Sentinel R8.1 Release Notes

Release Date: November 2017

If the battery is present the following pop-up is displayed:

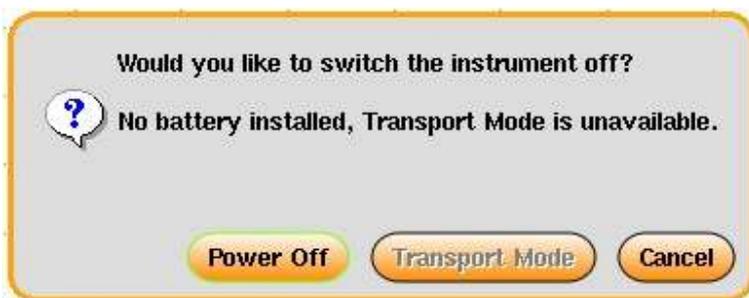
Powering Off Sentinel Has Been Simplified

Sentinel can be fitted with a battery option that allows the internal Rubidium oscillator to remain powered while Sentinel is powered down, maintaining the 1PPS phase information. Previous versions of firmware presented a pop-up to confirm that Sentinel should be powered down, followed by a second pop-up asking if the battery should be used (Transport Mode).

These pop-ups have been replaced by a single pop-up with all options displayed.
